Withlacoochee River Watershed Initiative Peer Review

September 2020

Singhofen & Associates, Inc. (SAI) was contracted by SWFWMD to conduct a Peer Review of several models including existing-condition and various scenario models. The review also included supporting data (GIS files, reports, etc.) developed for the Withlacoochee River Watershed Initiative (WRWI).

Figure 4.5 – Node Stage Instability (Verification Storm)

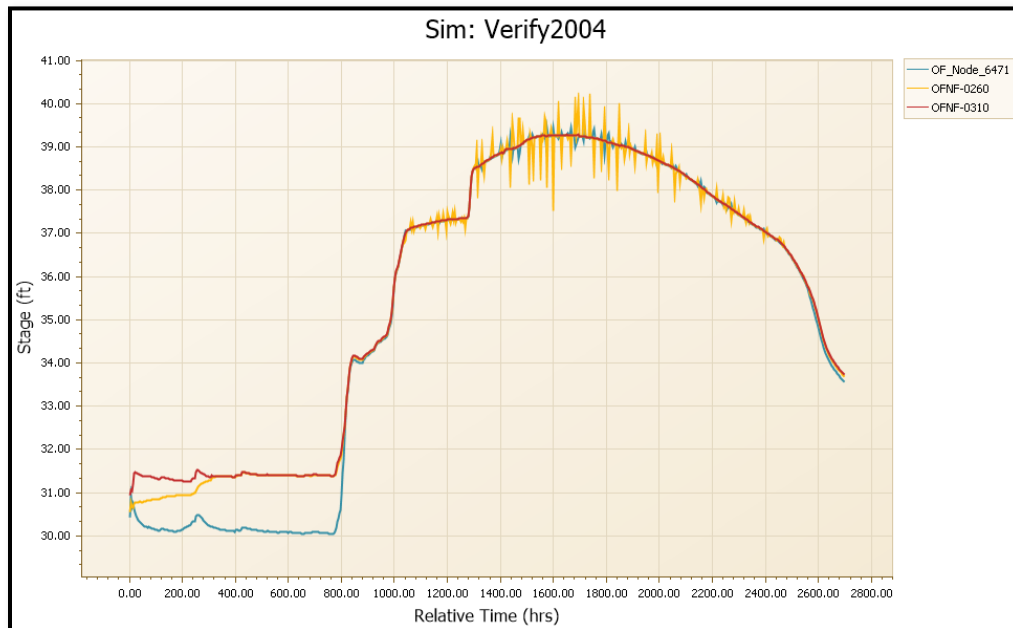
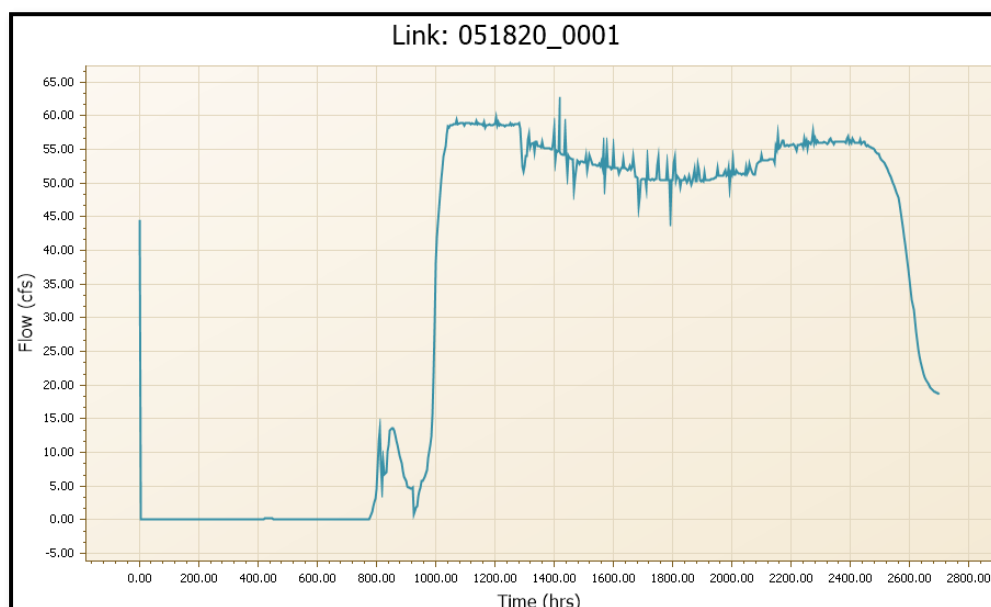
Appendix C-4 lists three nodes at which significant stage instability was identified. One of the locations (Node_1639) has some instability in the rising limb of the hydrograph, however, stages during peak conditions stabilize. The other two locations (1D interface nodes OFNF-0260 and OF_Node_6471) exhibit stage instability through peak conditions (see **Figure 4.5**). These locations are just upstream a culvert identified in **Section 3.3.7** as having differing geometries defined in the link data (Link: 051820_0001). The location is just downstream of the S-353 outfall structure from Tsala Apopka and provides a low-level outfall from the Potts Preserve area. The worst case is located at Node: OFNF-0260, however, the impact is reduced with distance from that location (see **Figure 4.5**). Furthermore, flow out of this area, while somewhat impacted, is only marginally affected (see **Figure 4.6**) and has no impact on downstream locations.
